Intel® 82571EB/82572EI Ethernet Controller

Specification Update

*July 2010
Revision 6.3*

26. Firmware Reset Occurs when Performing Transactions with a Low Interpacket Gap (IPG) Using Fast Management Link (FML) at 8MHz.

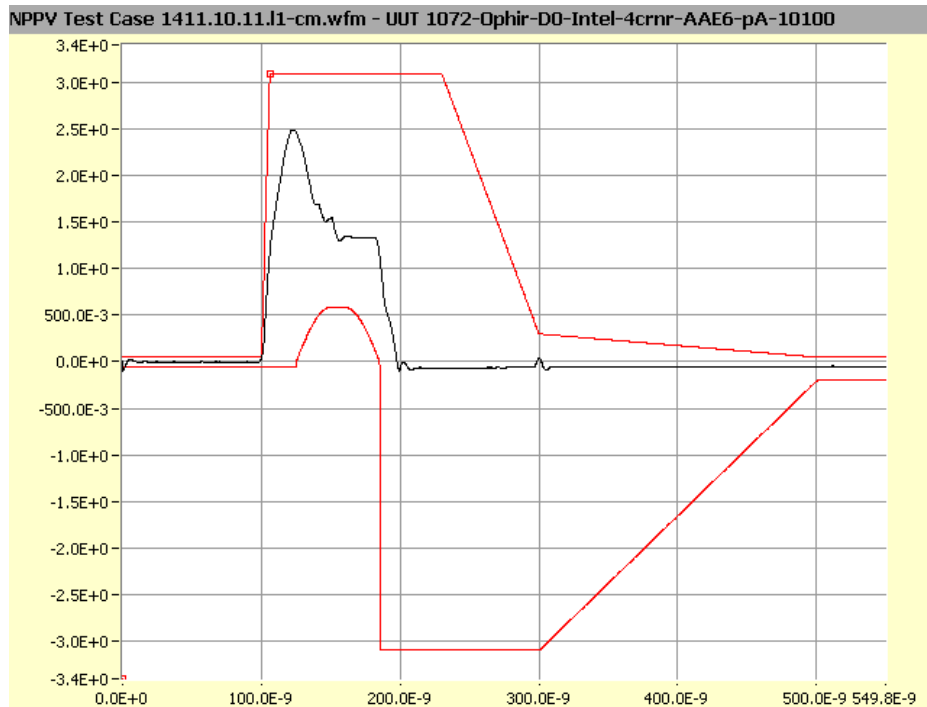
Problem: A single firmware reset occurs when FML 8MHz transactions are delivered with an Inter-Packet-Gap (IPG) smaller than 20uSec. Due to speed and memory limitations, buffers of BMC frames being arranged into Ethernet packets are incorrectly released. As a result, a memory error (Null pointer exception) occurs.

Implication: Performance impact. The BMC must retry the corrupted transaction.

Workaround: The BMC should not transmit with an IPG lower than 30usec.

3. System-Level EMI Test Can Be Affected by 490MHz Harmonic Seen In 10Base-T Waveform Spectrum.

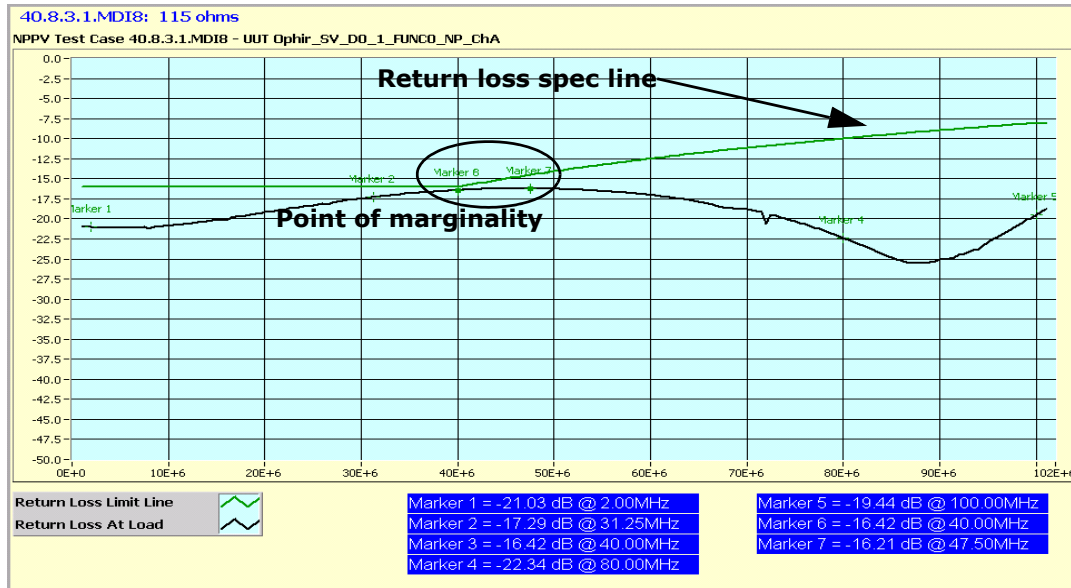
Clarification: This is not a violation of any IEEE specification. This harmonic may, however, contribute to EMI (electro-magnetic interference) in a system-level check at this frequency.

There is no impact on system-level performance.
